Committee of Adjustment

Comments from Staff, Public and Agencies

Thursday, September 10, 2020, 4:00 p.m.

SCHEDULE "B"

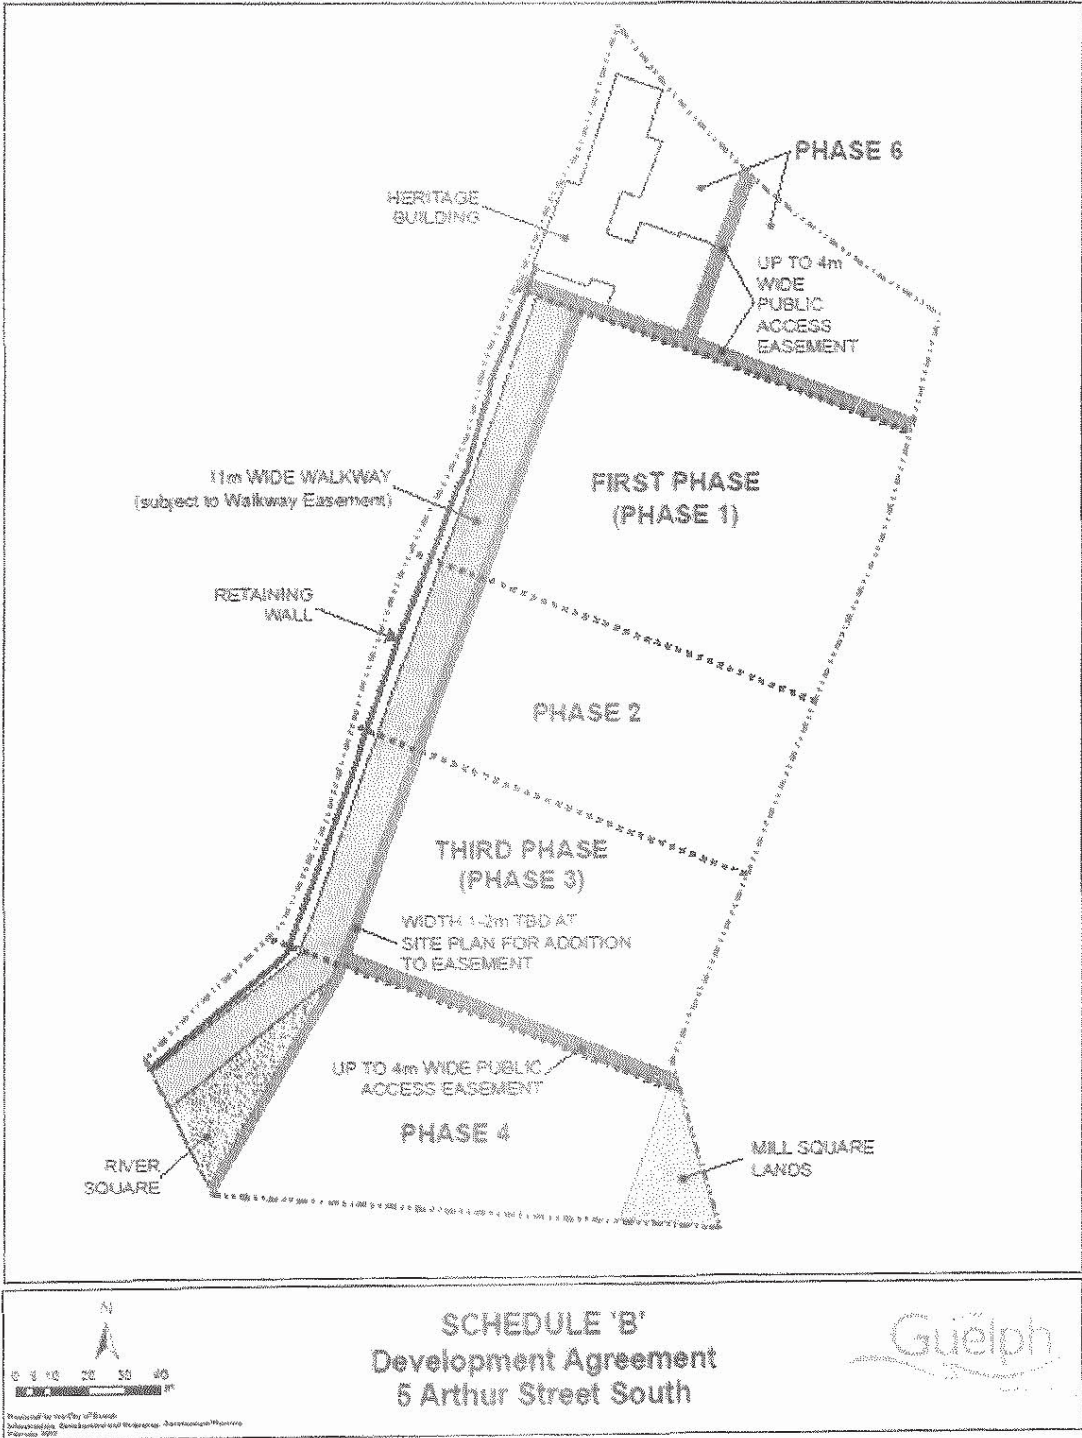
Please see attached 'Schedule B' from the development agreement regarding the location of the easement, and Part IX - Park Dedication/Cash in Leu, clause 9.1(a) regarding the transfer of these easements to the City.

73 and 93 Arthur Street,
Guelph

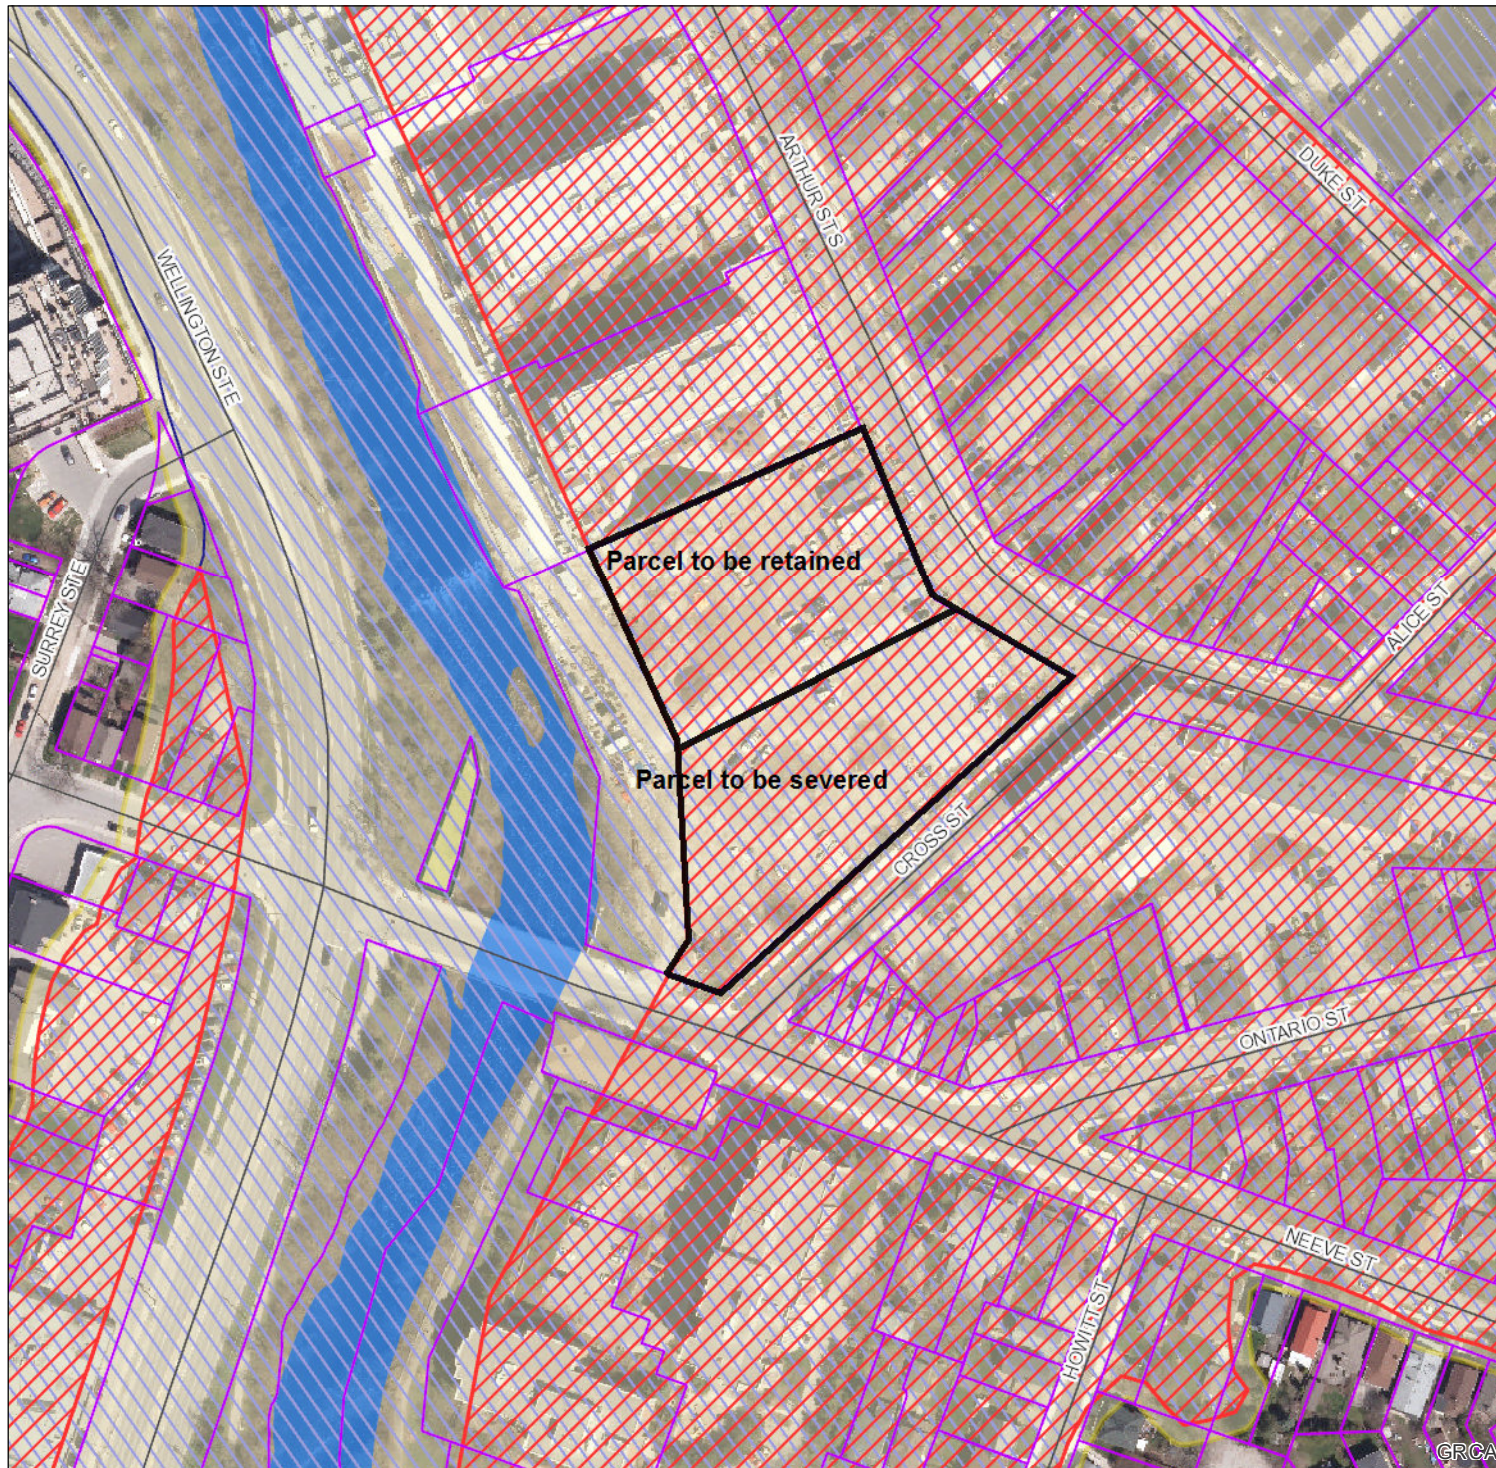
Information currently available at this office indicates that the proposed retained and severed lands are within the floodplain of the Speed River and are identified as Special Policy Area.

The property is subject to the policies for development within the Special Policy Area found in the City of Guelph's Official Plan and Zoning By-law that allow for the creation of a new lot in the floodplain, subject to meeting technical criteria. Based on our review, the lots will meet the access criteria for the creation of new lots in the SPA. We would ensure conformance with the remaining technical requirements at detailed design.
